To: jdichoso@fcc.gov  
FCC Application Processing Branch  
Re: FCC ID EO9PET  
Applicant: Itron Inc  
Correspondence Reference Number: 13030  
731 Confirmation Number: EA95767  
Date of Original E-Mail: 03/27/2000

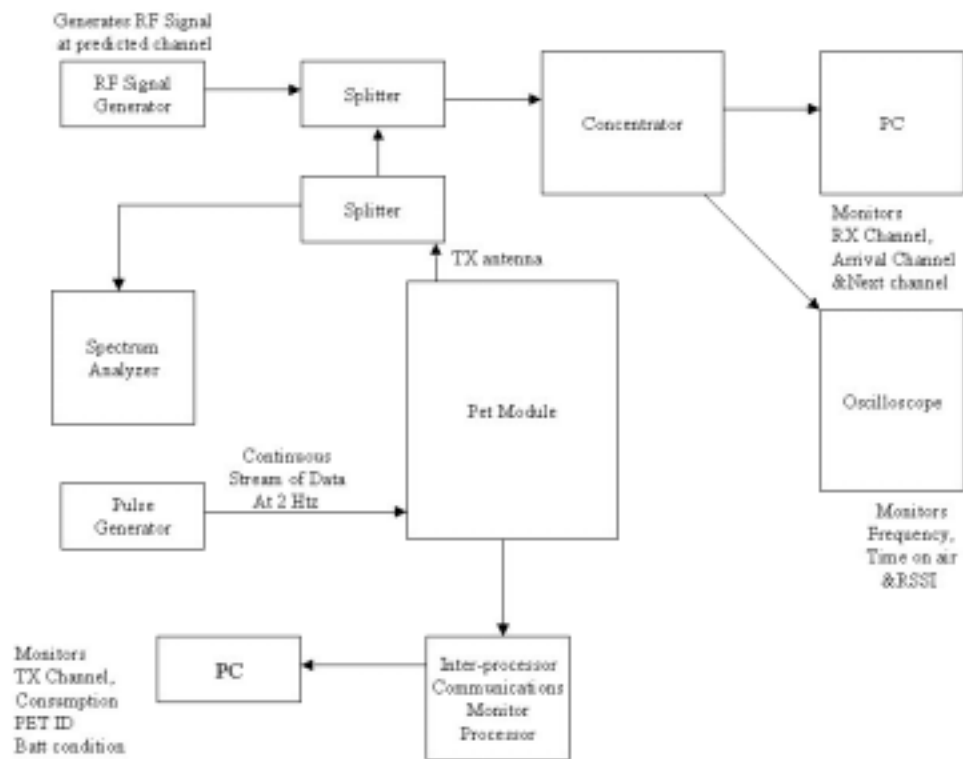
We have implemented the suggested test plan submitted to you for approval on March 28. The equipment was set up as shown in the block diagram provided on the following page. The PET transmitter was fed a continuous data input and we were able to accurately monitor the actions of the transmitter and receiver with test equipment and to document the specific channel activity with the PC's. We have a lot of supporting data should you be interested in any additional detailed data.

We confirmed that both transmitters used each frequency equally on the average. The transmitter stepped through all of the 25 pseudo randomly ordered channels before reusing a frequency. A maximum length data packet (138 ms) was transmitted on each channel. We confirmed this with the spectrum analyzer by looking at each anticipated frequency as the transmitter hopped channels. We also compared the new hop table list of the hop frequencies and channels assigned to each of the 2 serial numbers for conformity with the frequencies actually observed with the two transmitters tested. We monitored and documented the transmitter channel, consumption, PET ID and battery condition.

We also confirmed that the receiver tracked the transmitter accurately stepping to the next anticipated channel based on the transmitters hop table, just ahead of the transmitter. We monitored the receive channel, arrival channel and next channel with the PC.
